## REMARKS

## DRAWING AMENDMENTS

Fig 1

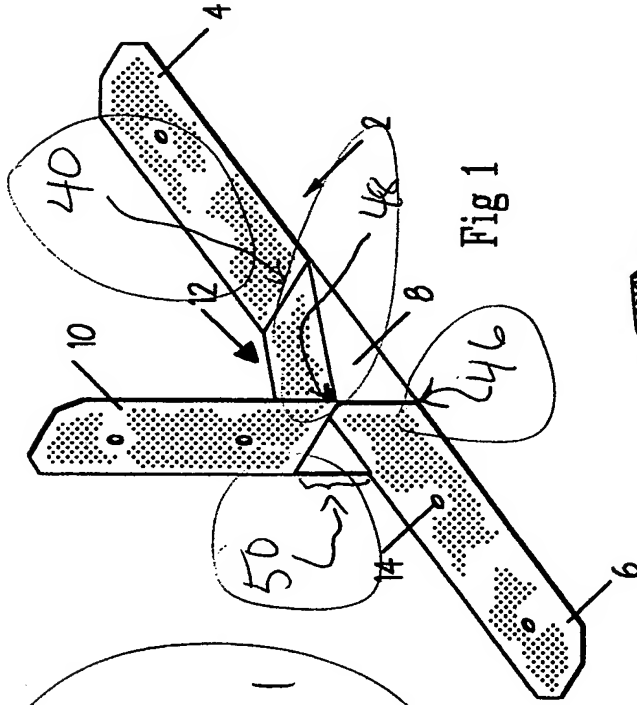
#1's  
 50,401  
 46 + 48  
 were  
 added  
 to  
 Fig. 1

Fig 3

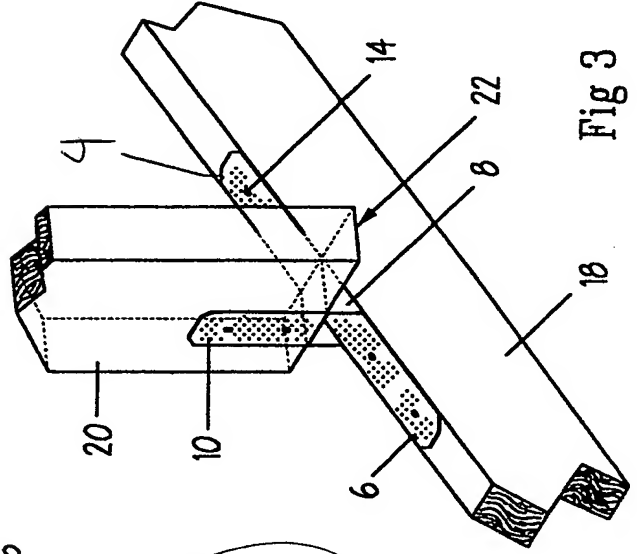
the #4  
 was  
 added  
 to  
 Fig. 3

Fig 4

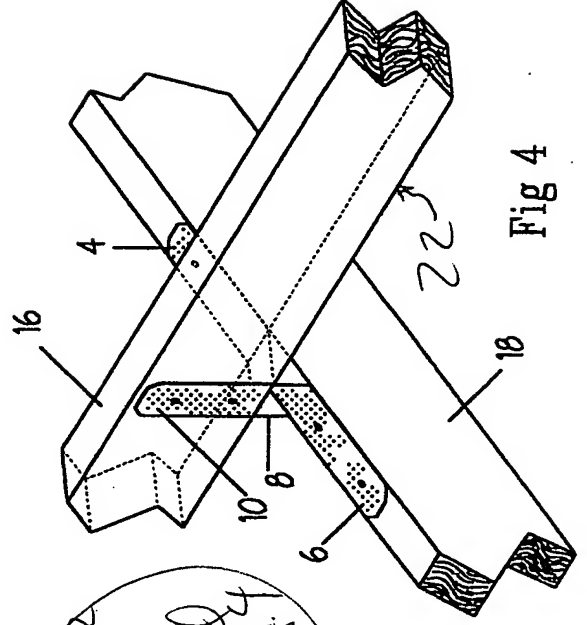
the #22  
 was  
 added  
 to  
 Fig. 4

Fig 5

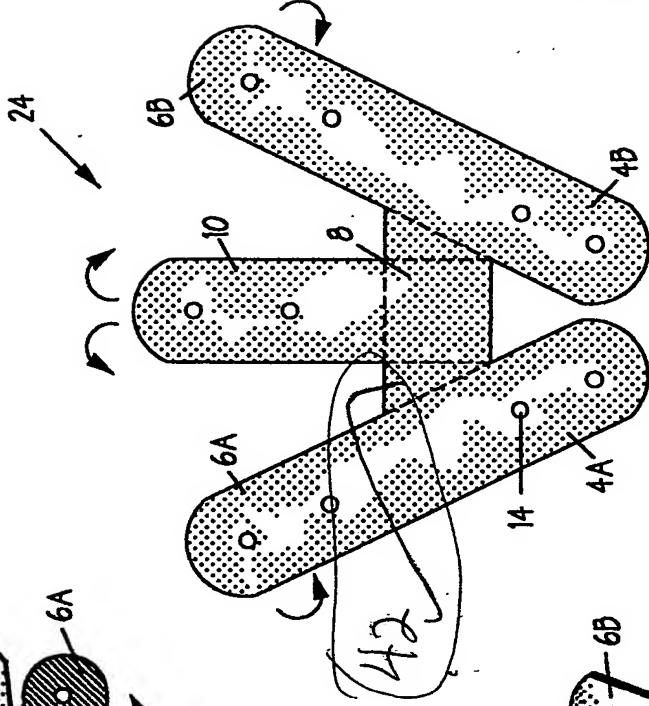
#42 was added to Fig. 5

Fig 15

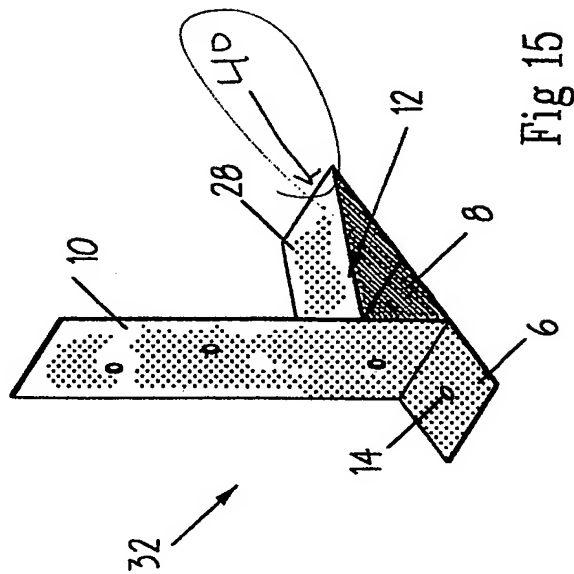
The #'s 40 14e  
 + 14d were added to Figs 15 + 16

Fig 17

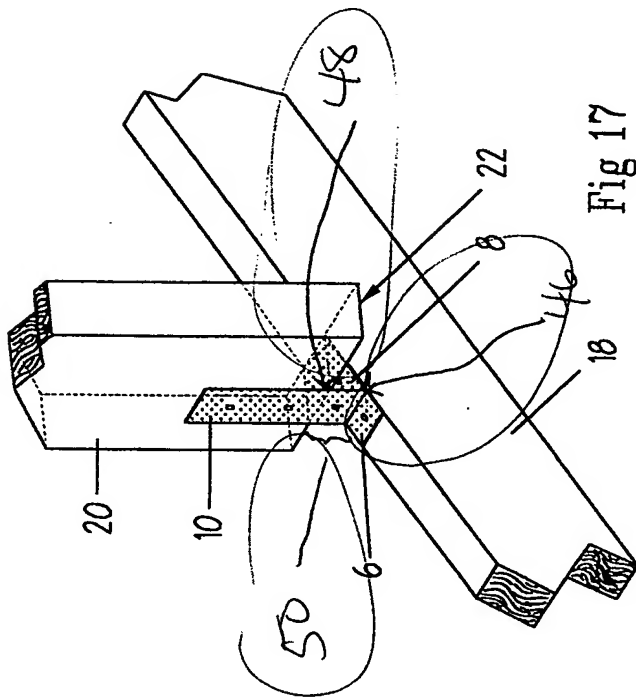
Also the #s 50, 48 + 46 were added to Fig. 17

Fig 19

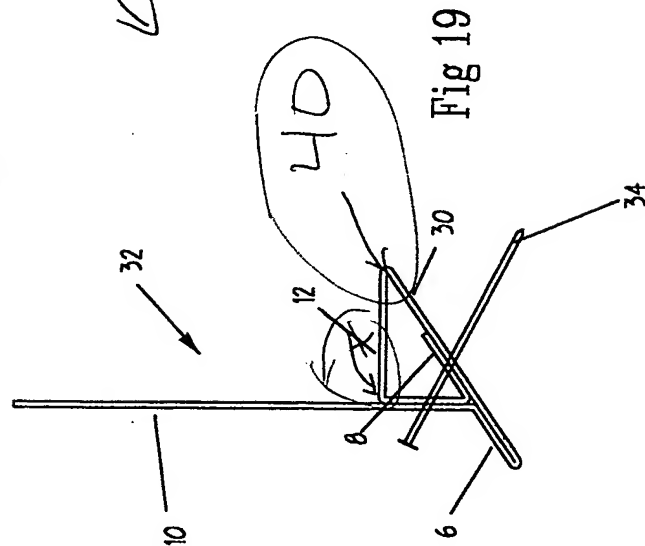
The arrow extending was reangled for accuracy + the # 48 was added to Fig 19

Fig 21

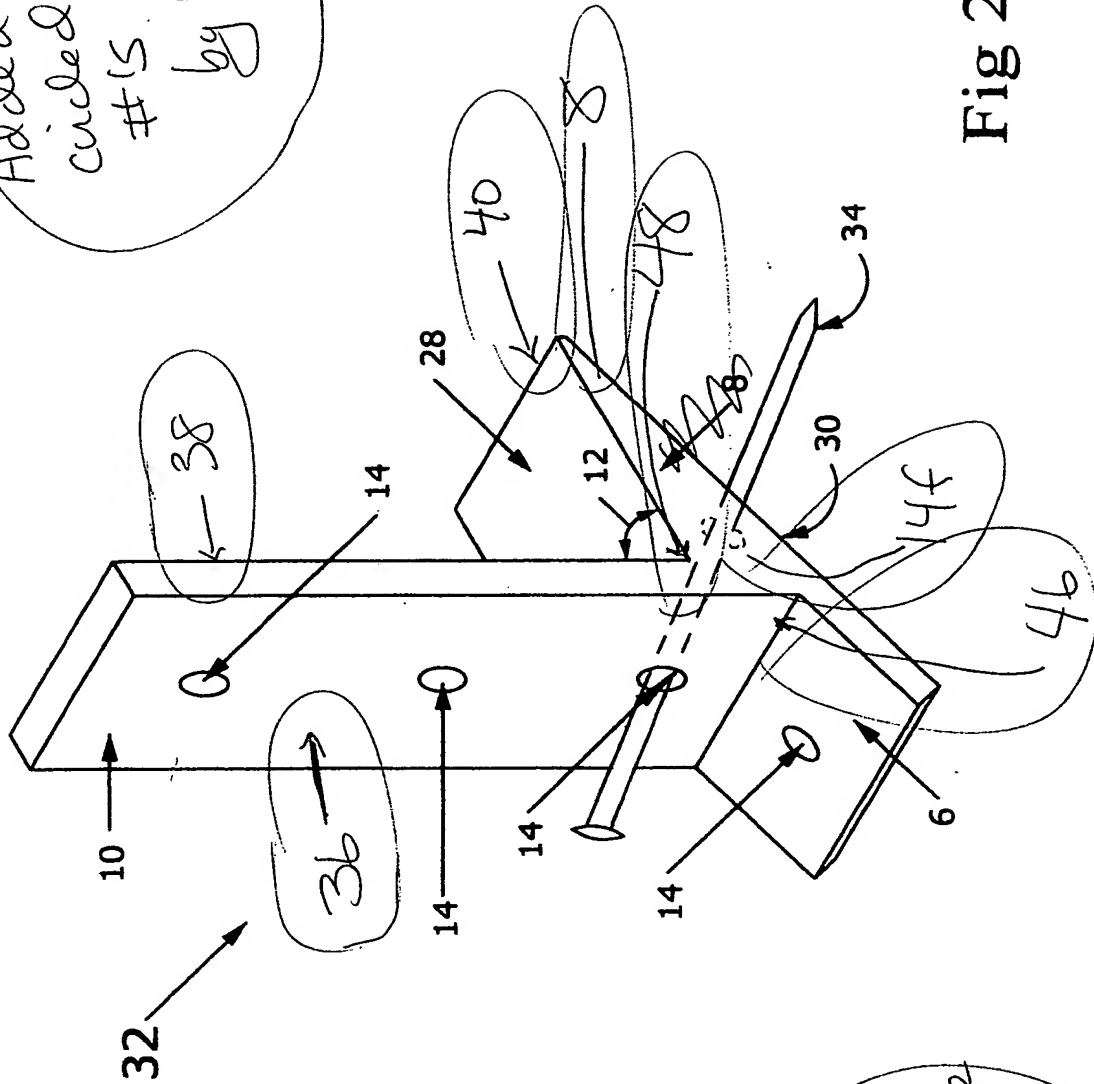
Added  
 circled  
 #'s drawn  
 by Hand

Also #  
 8
